RHODE ISLAND DEPARTMENT OF TRANSPORTATION

1R Improvements to Rt. 107

NOTICE TO PROSPECTIVE BIDDERS

ADDENDUM NO. 2 Prospective bidders and all concerned are hereby notified of the following changes in the Plans, Specifications, Proposal and Distribution of Quantities for this contract. These changes shall be incorporated in the Plans, Specifications, Proposal and Distribution of Quantities, and shall become an integral part of the Contract Documents.

GRADE PLAN NO.2

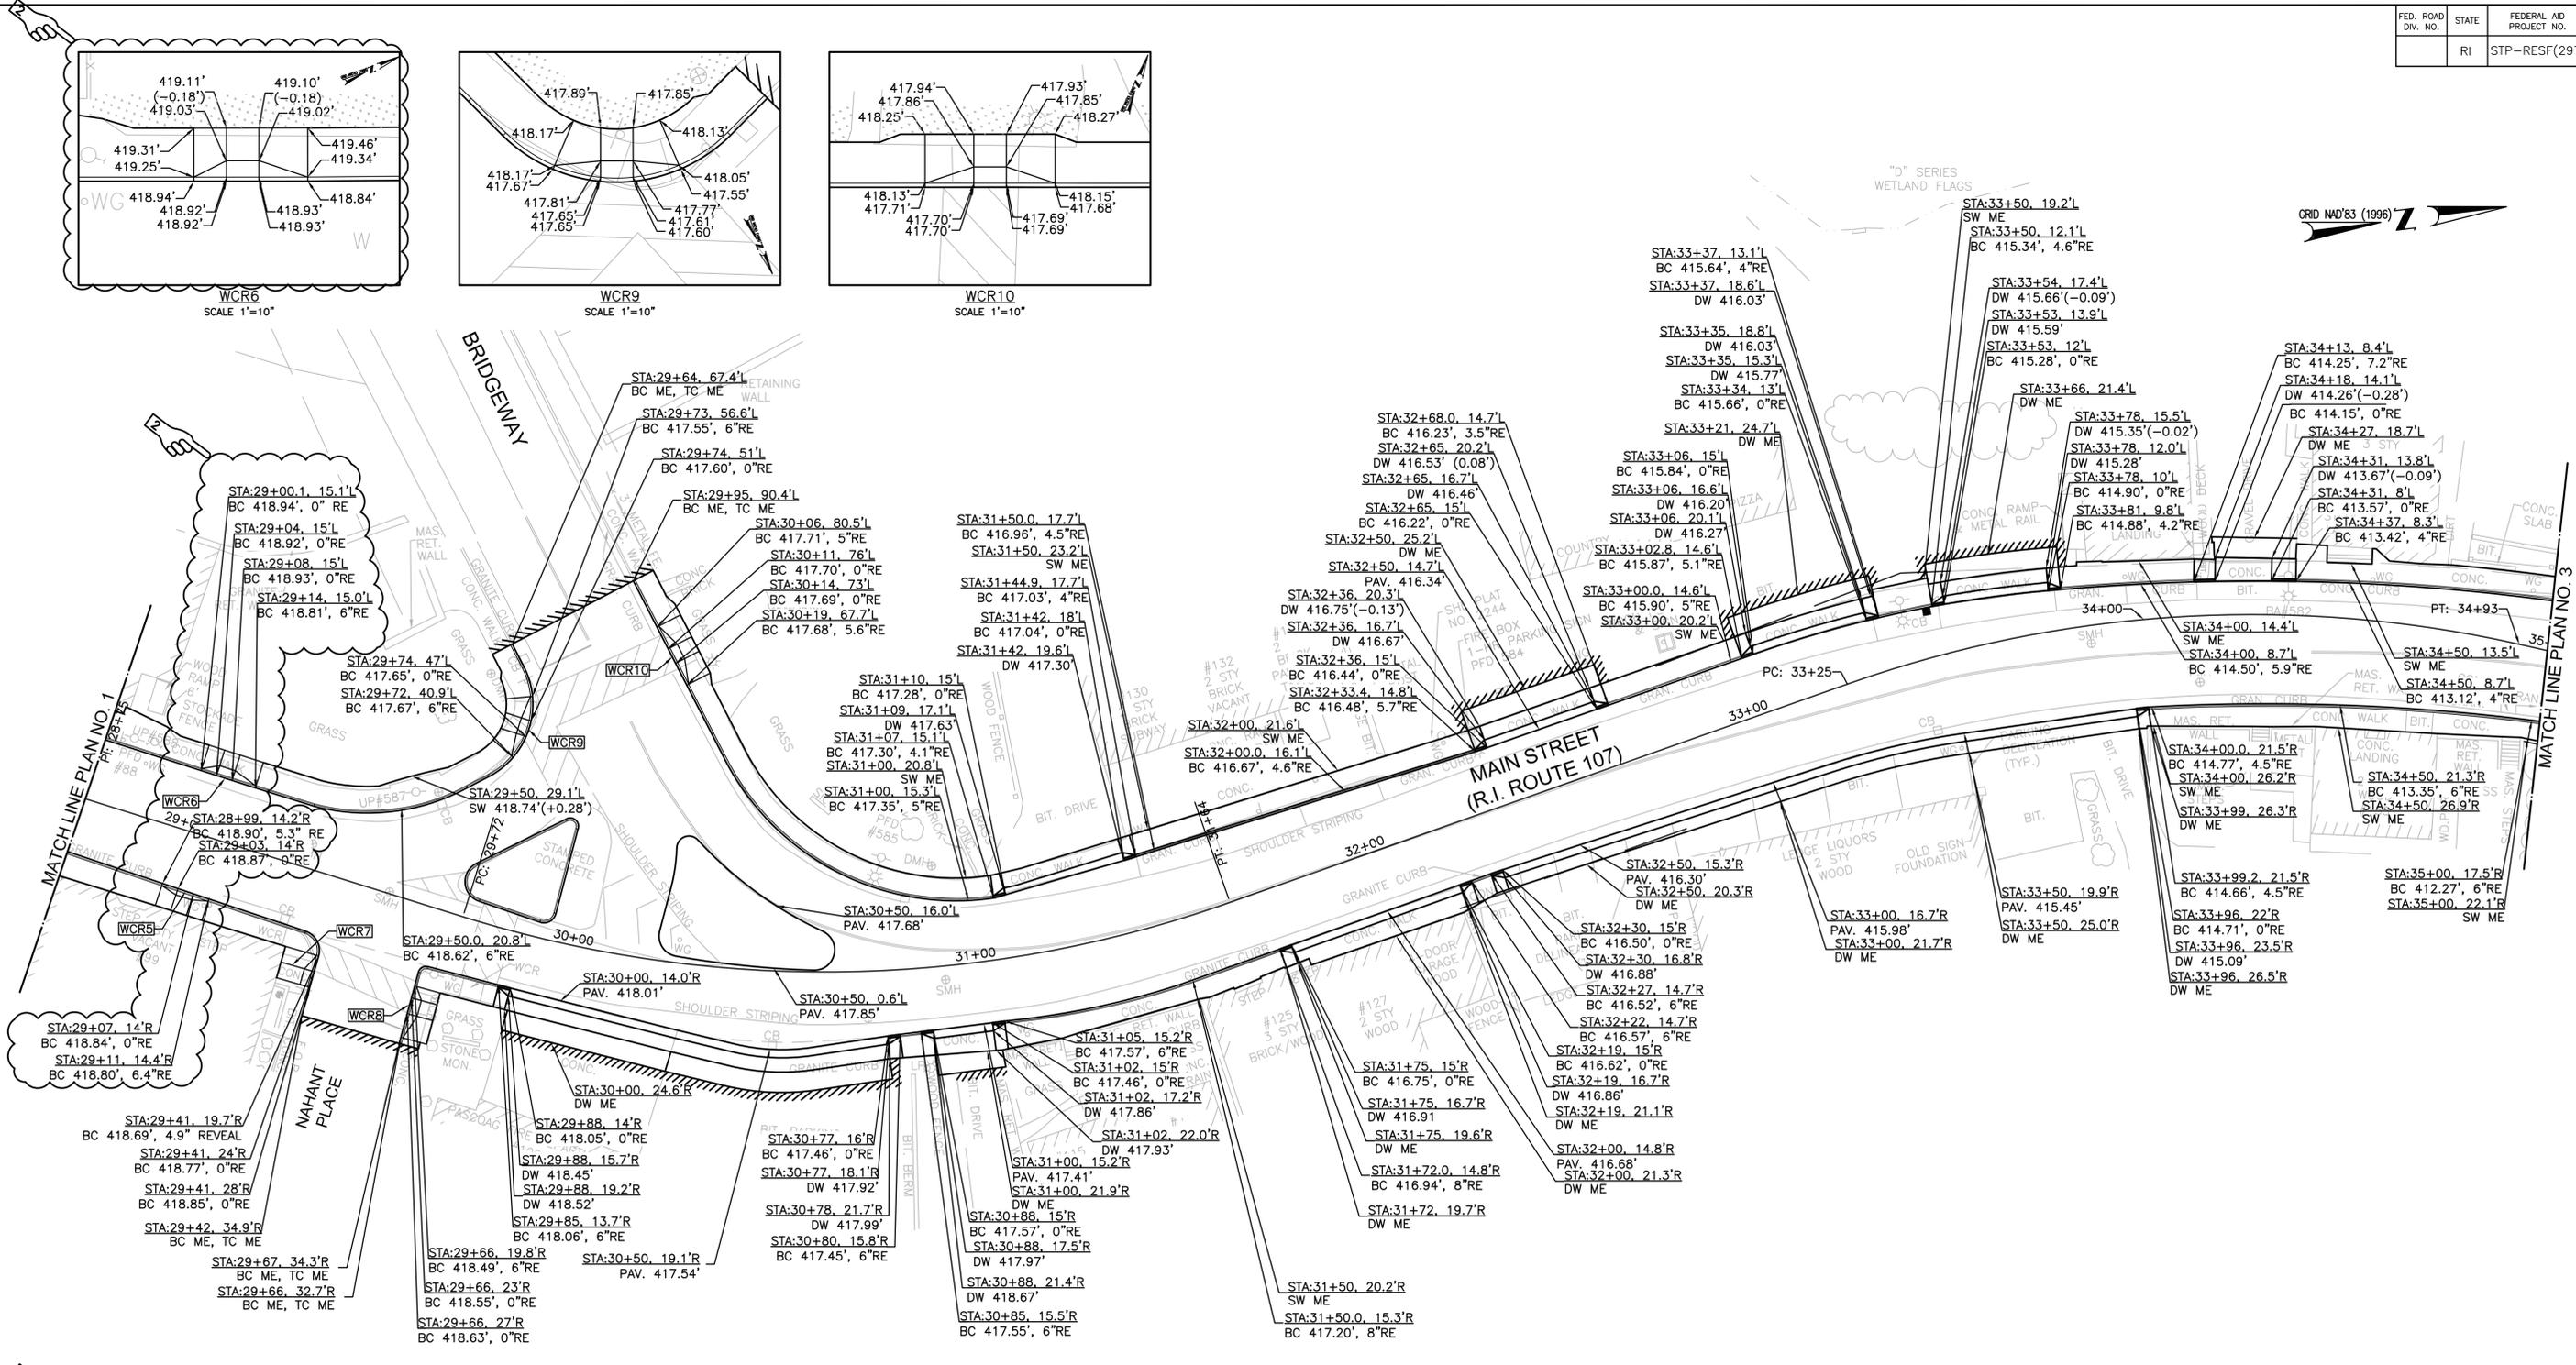
Delete Sheet No. 51 - Grade Plan No. 2 in its entirety and replace it with Sheet No. 51 - Grade Plan No. 2 (R-1) attached to this Addendum No. 2. Curb ramp locations have been revised.

GRADE PLAN NO.4

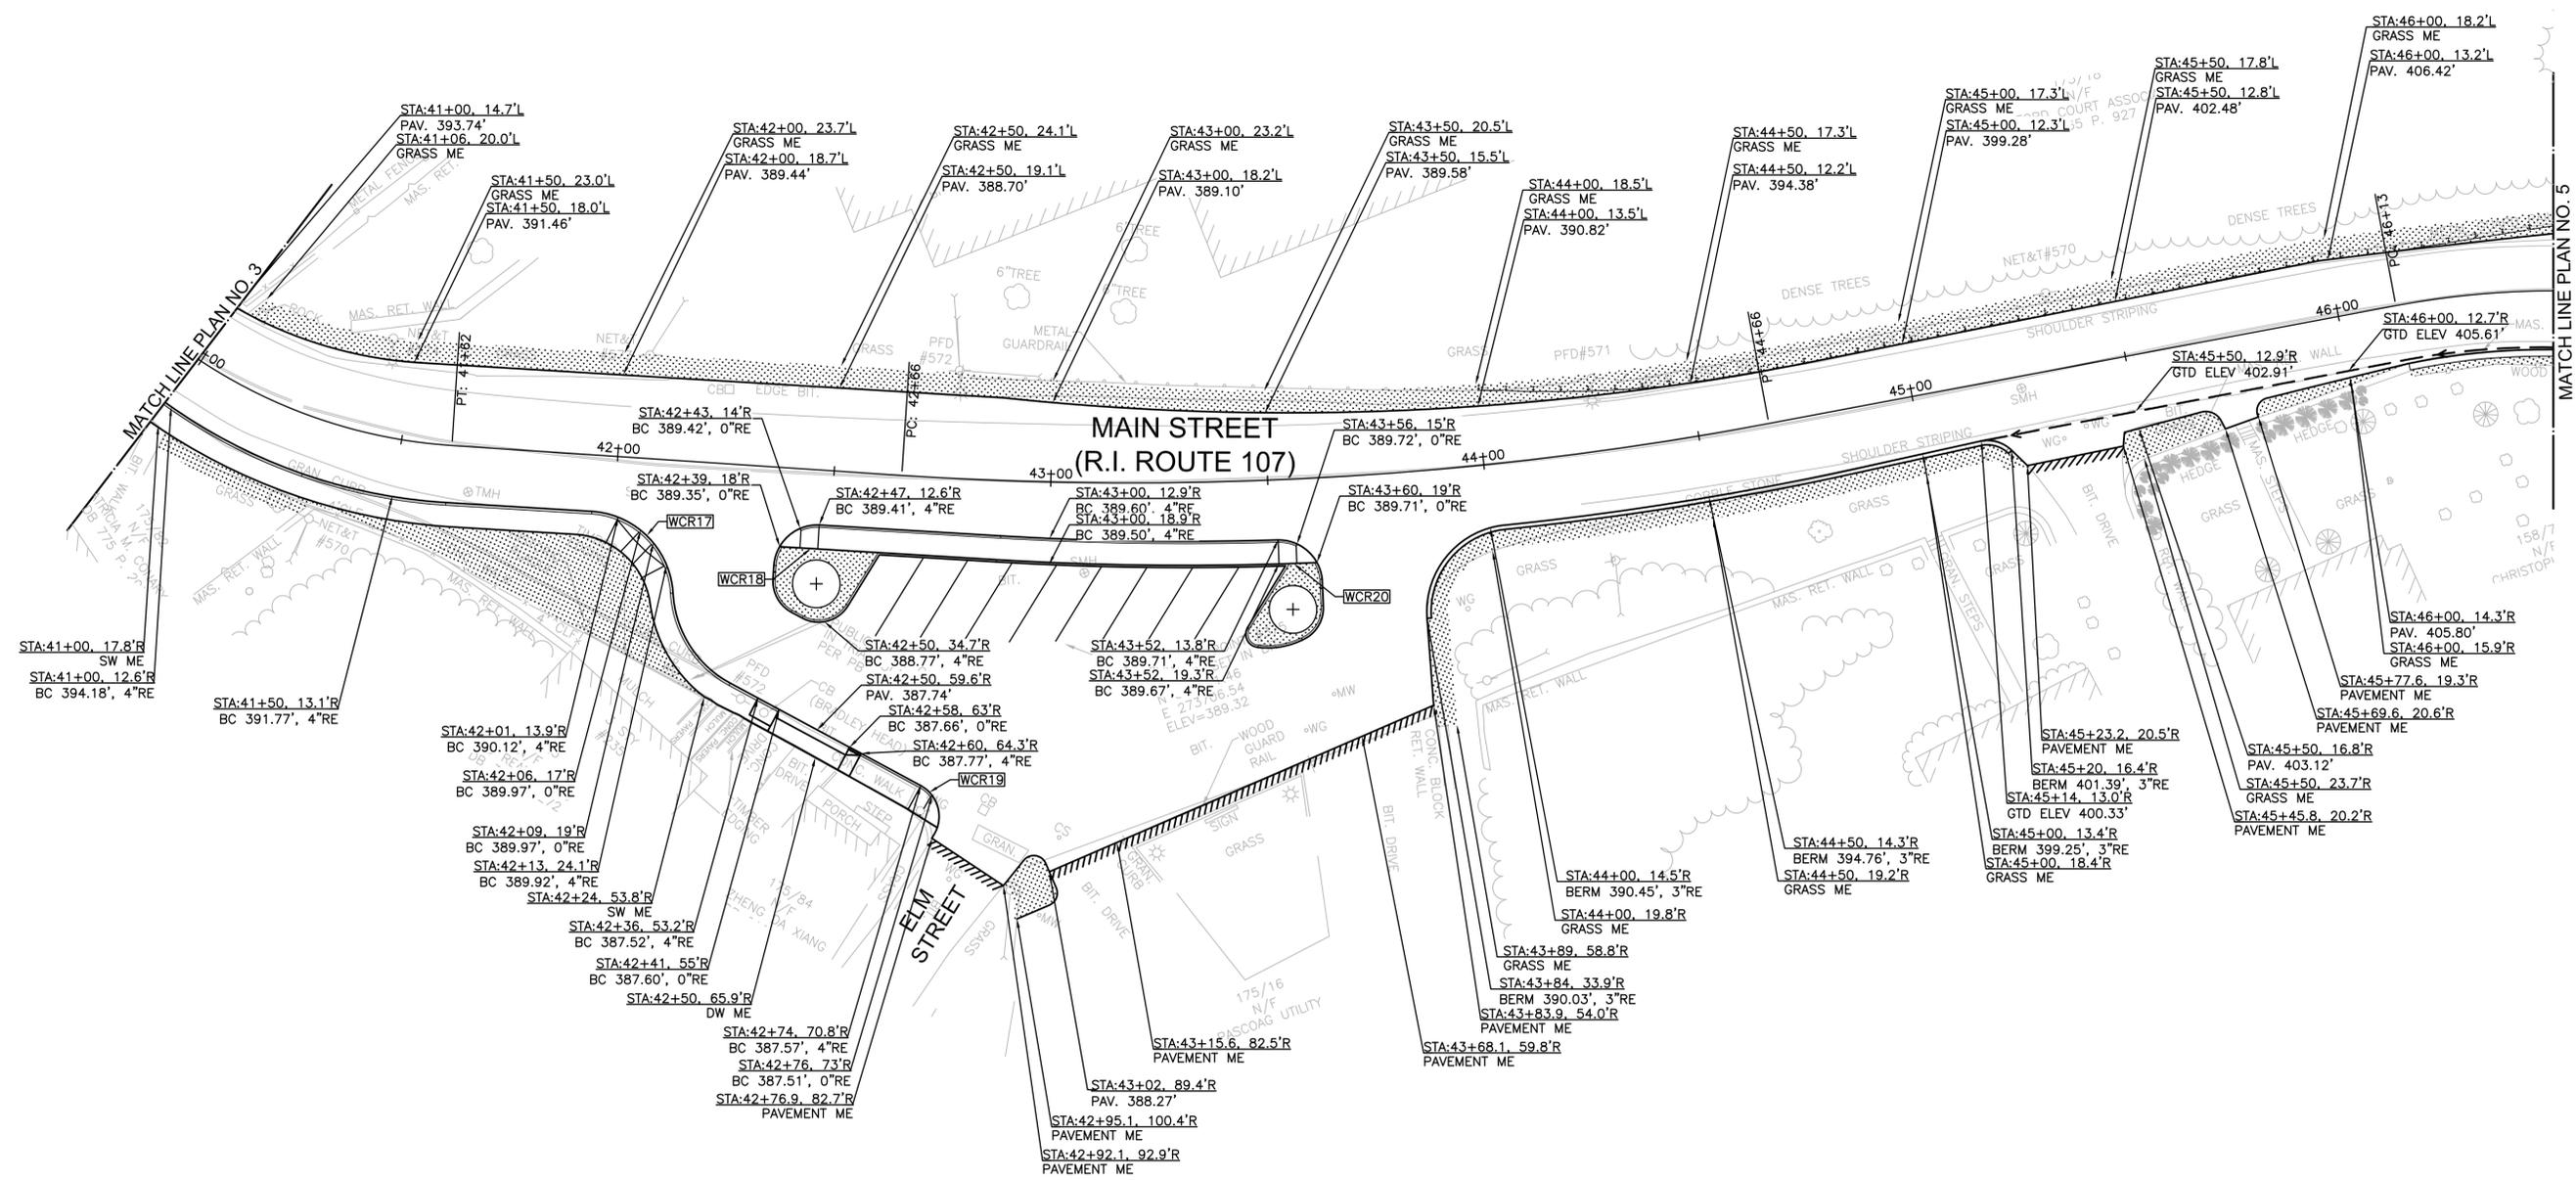
Delete Sheet No. 53 - Grade Plan No. 4 in its entirety and replace it with Sheet No. 53 - Grade Plan No. 4 (R-1) attached to this Addendum No. 2. A curb ramp (WCR18) grade has been revised.

LOCATION PLAN NO. 1

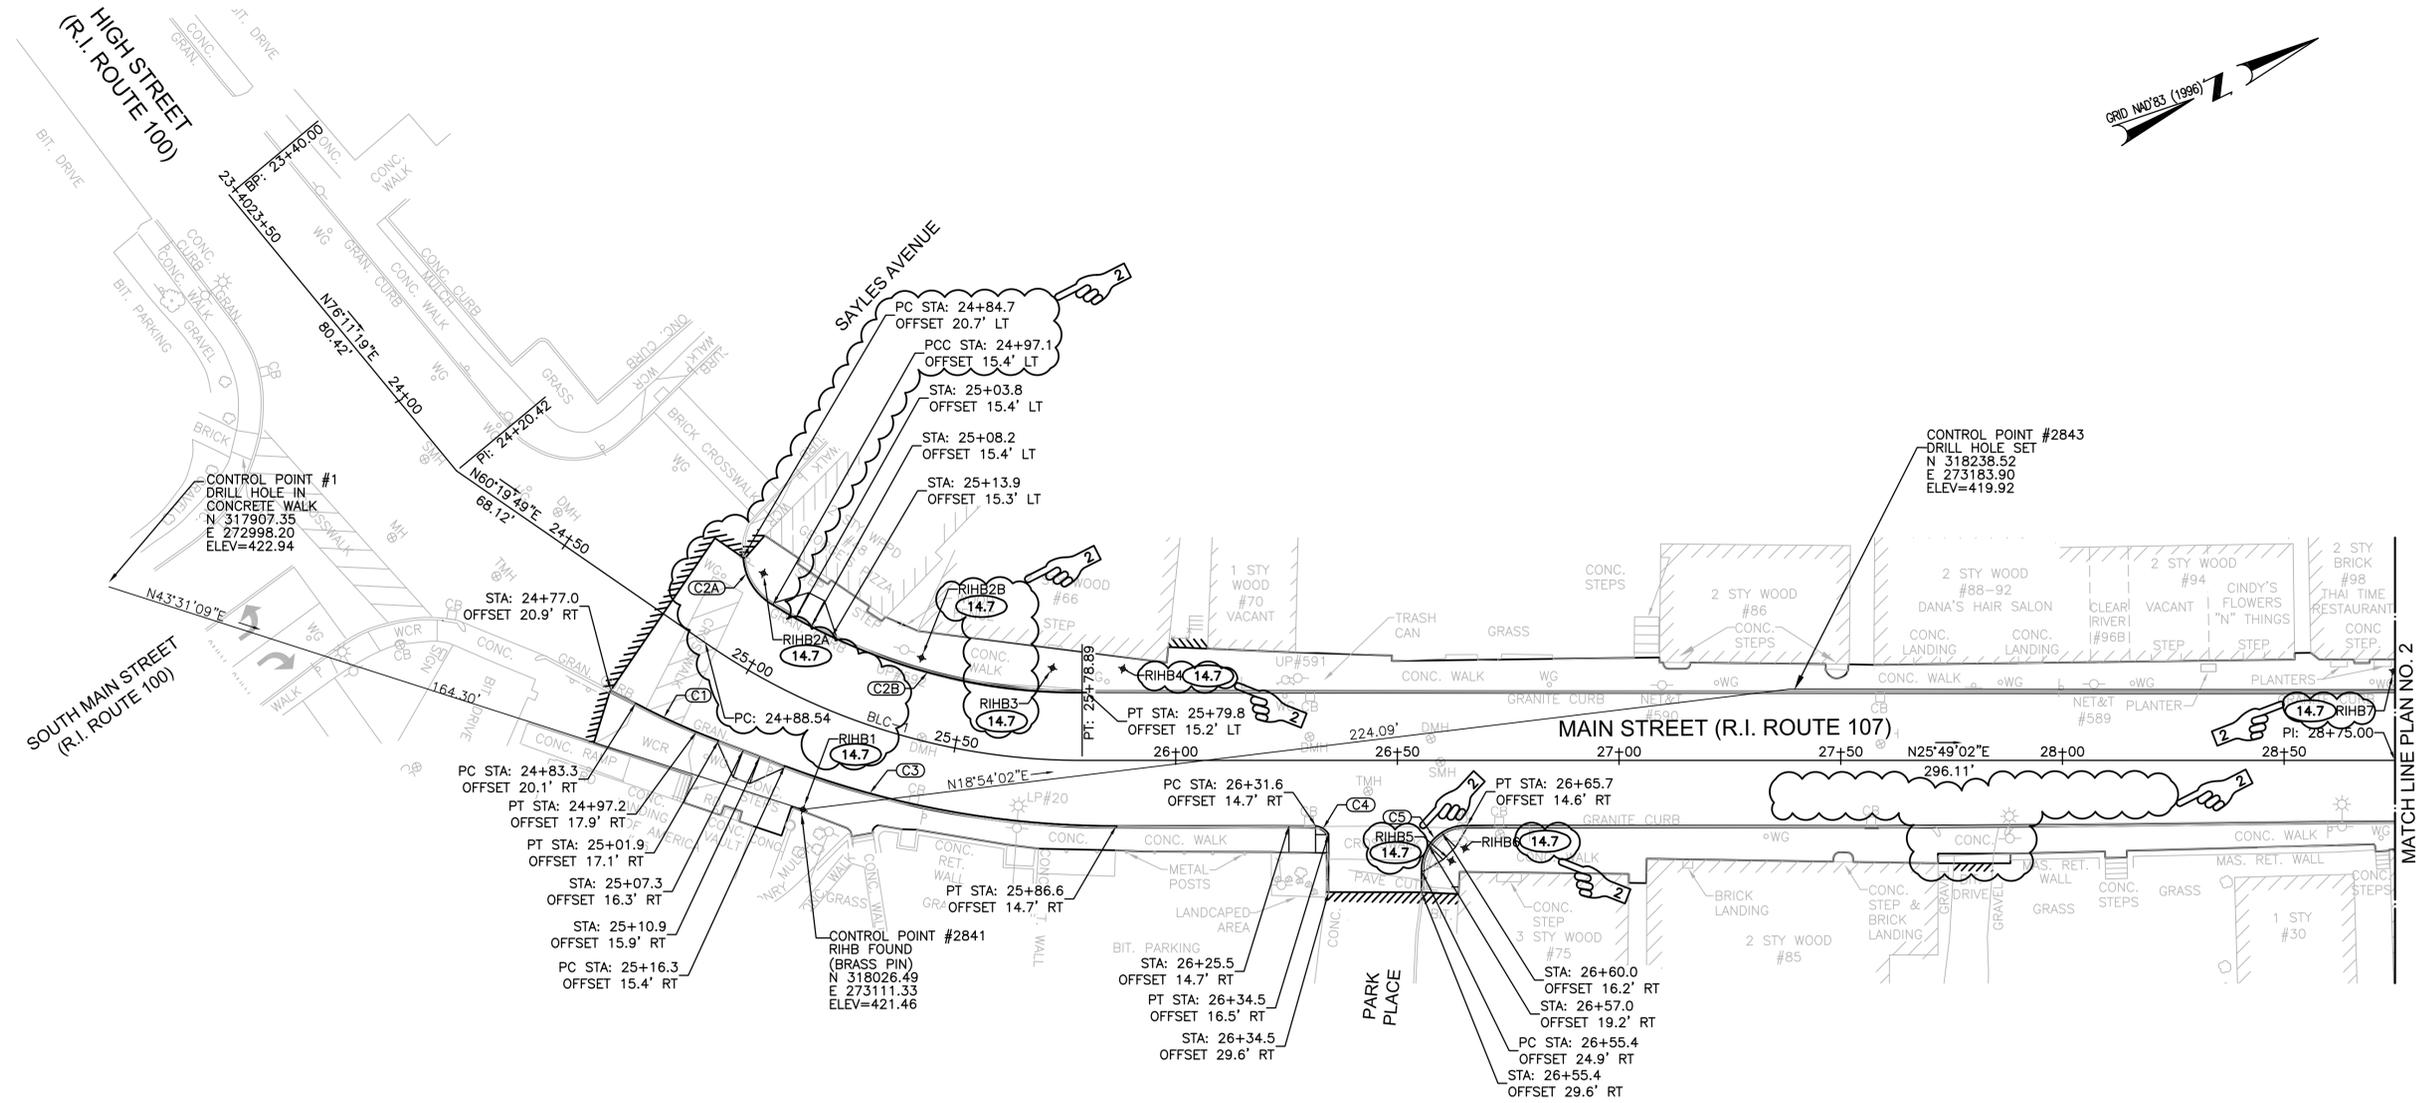
Delete Sheet No. 58 - Location Plan No. 1 in its entirety and replace it with Sheet No. 58 - Location Plan No. 1 (R-1) attached to this Addendum No. 2. Sidewalk limits near Sayles Avenue have been revised, a driveway has been removed and highway bounds have been revised/added.
